AMENDMENTS TO THE DRAWINGS:

REMARKS

In the Office Action dated June 25, 2007, the Examiner has rejected/objected to claims 1-44, 72, 73, the drawings, and the specification. By this response, Applicants have amended claims 1, 2, 4, 10, 13, 15, 16, 19, 24, 27, 28, 33-36, and 38, canceled claims 8, 32, 72 and 73, amended the specification and drawings. After entry of this paper, claims 1-7, 9-31, and 33-44 remain pending in the application. Applicants believe that all the rejections and objections have been addressed in this response.

FIG. 1A

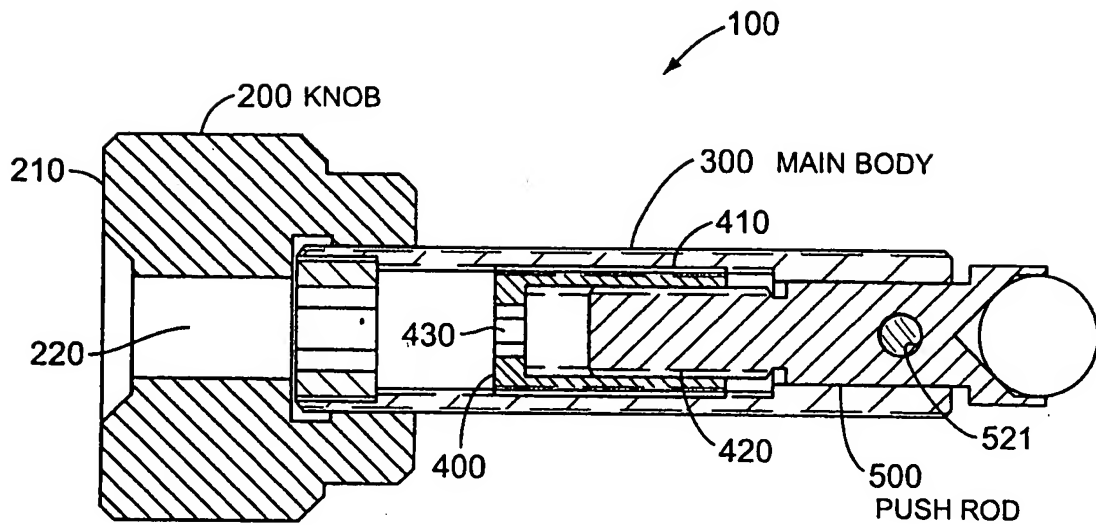
With respect to **Item 6(a)**, the dowel pin 521, the housing 300, and the push rod 500 are shown in the amended FIG. 1A and FIG. 1C. FIGS. 2A and 2B now better show a slot 340

With respect to **Item 6(b)**, Applicants respectfully submit that FIG. 1A shows that the first threaded surface 410 is an external threaded surface and the second threaded surface 420 is an internal threaded surface.

In **Items 12 and 13, first section**, claims 4 and 28 were rejected because, as stated by the Examiner, it is unclear as to how dowel pin 521 engages both the housing 300 and the rod 500 as claimed. Applicants respectfully disagree with the Examiner's assertion.

The dowel pin 521 is clearly shown in FIG. 1A and FIG. 1C. With this response, Applicants amend FIGS. 1A and 1C to add fillings in the circle denoted by reference number 521 to show that it is a cross-sectional view of the dowel pin 521. Even before this amendment,

FIG. 1B

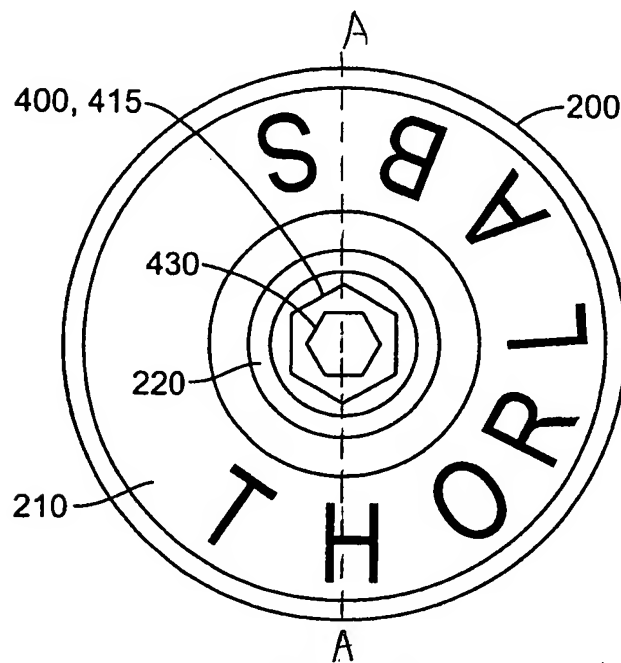
With respect to **Item 3(b)(2)** in the Office Action, Applicants have amended FIGS. 1B, 1D, and 1F and brief description of the drawings to show the sectional plane, upon which the cross-sectional views of the figures were taken.

FIG. 1F

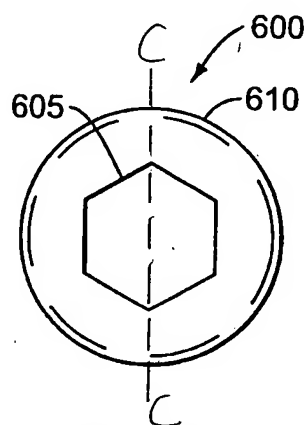
With respect to **Item 3(a)** in the Office Action, Applicants amend the specification to add a new paragraph briefly describing FIG. 1F (please refer to the Amendments to the Specification section).

FIG. 1G

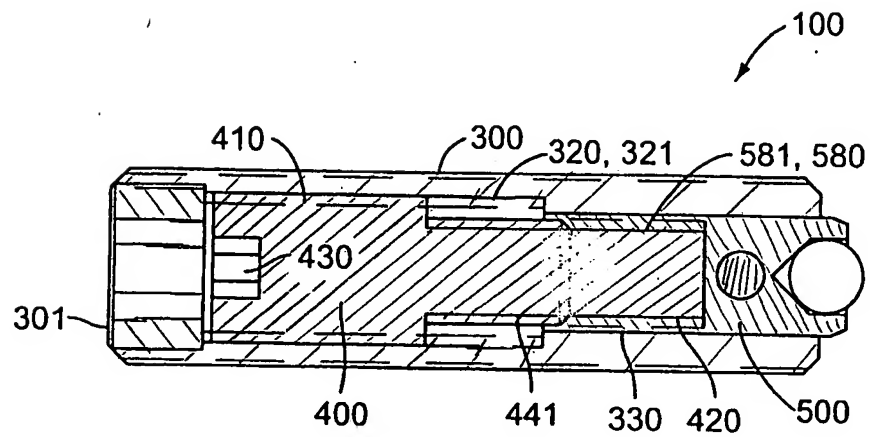
With respect to **Item 3(b)(1)** in the Office Action, Applications have amended FIG. 1G to show a cross-sectional view.

With respect to **Item 6(c)**, Applicants respectfully submit that FIG. 1G shows that the first threaded surface 410 and the second threaded surface 420 are both external threaded surfaces.

In **Item 13, third section**, claims 6 and 30 were rejected as it is unclear how the first and second threaded surfaces 410 and 420 are external surfaces. Applicants respectfully submit that FIG. 1G (originally FIG. 1F) clearly shows that the first threaded surface 410 and the second threaded surface 420 are external to the sleeve 400. Moreover, the structure is described in the specification. For example, paragraph [049] of the specification describes that “[i]n the embodiment shown in FIG. 1G, both first threaded surface 410 and second threaded surface 420 of intermediate actuator sleeve 400 are formed on an external surface 441 of intermediate

actuator sleeve 400.” Applicants respectively submit that, in view of FIG. 1G, and the corresponding description in the specification, a person skilled in the art should appreciate that the first threaded surface 410 and the second threaded surface 420 can be external surfaces.
